APPLICATION NUMBER: 23/00985/FUL

DELEGATED DECISION CHECKLIST AND REPORT

Address: Land Adjacent To 34 Queen Street Heywood OL10 4JY

Proposal: Erection of 2.no 2 bedroom self-contained apartments

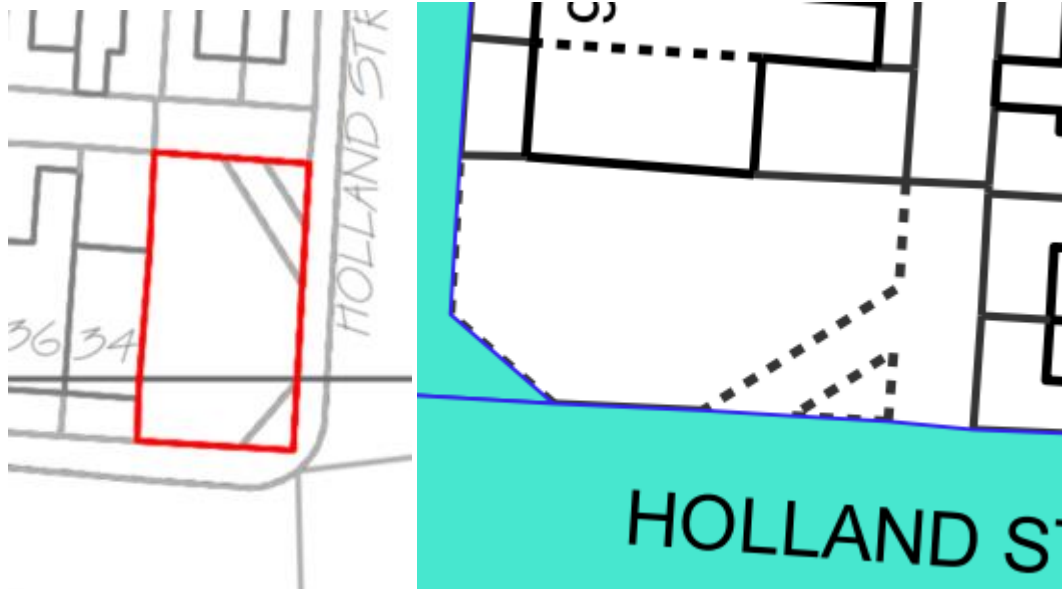
The Council's Highways Officer has been consulted and has raised concerns over the proposed development as the red edge of the development extends onto the adopted highway. It is the front boundary wall which extends onto the adopted highway, there is also an unadopted path in the south east corner of the site. Highways have raised concerns about this as it is likely to have attained highways rights by express dedication.

The above plans demonstrate how the red edge encroaches on the adopted highway shown in blue. This also shows the footpath at the corner of the site, this has been paved and is now an established part of the footpath.

The applicant has submitted an application for the proposed stopping of the highway however it is pending determination. Therefore at the time of determination of this planning application, the highways objection still stands. The application will have a negative impact on highway rights and consist of an illegal obstruction on the highway, this does not accord with the NPPF as it states development should, 'give priority first to pedestrian and cycle movement, both within the scheme and with neighbouring areas'. As the proposal would impact highway by reducing it, this is not considered acceptable.
